ADDENDUM NUMBER 1

MILWAUKEE COUNTY
CRIMINAL JUSTICE FACILITY
HOT WATER HEATERS REPLACEMENT
Site #240, Bldg. #76
949 North 9th Street
Milwaukee, WI 53233

Project Number: C120-16426
Notice Number: 7145

Date of Addendum: October 3, 2016

1. Sheet P1.1: Mechanical room New Work - Plumbing

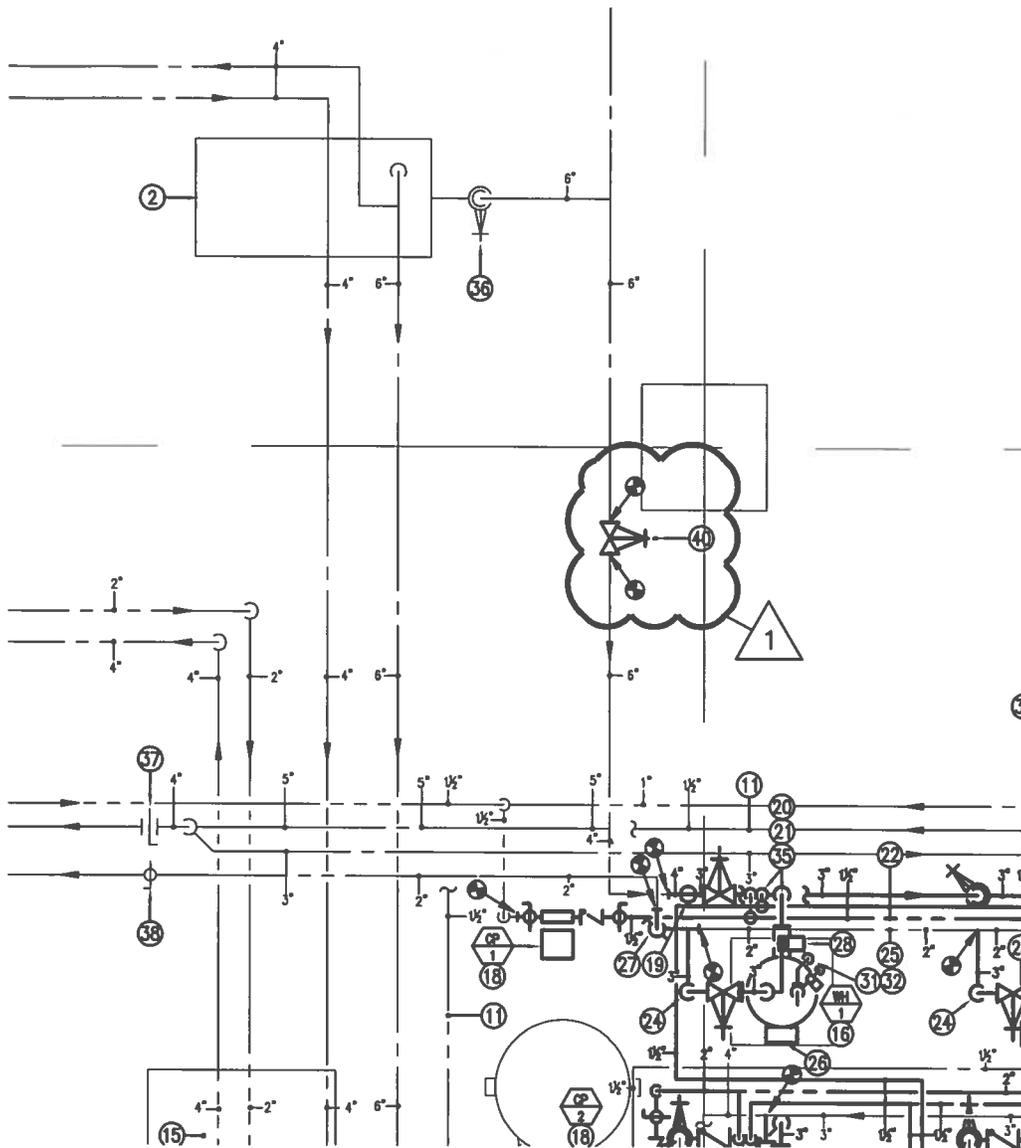
Add: Install "Wet Tap" isolation valve in 6" cold water pipe as indicated on drawing.

40. LOCATION OF "WET TAP" SHUT-OFF VALVE IN 6" CW PIPE SERVING LOWER FLOORS. COORDINATE EXACT LOCATION WITH EXISTING CONDITIONS AND WET TAP CONTRACTOR.
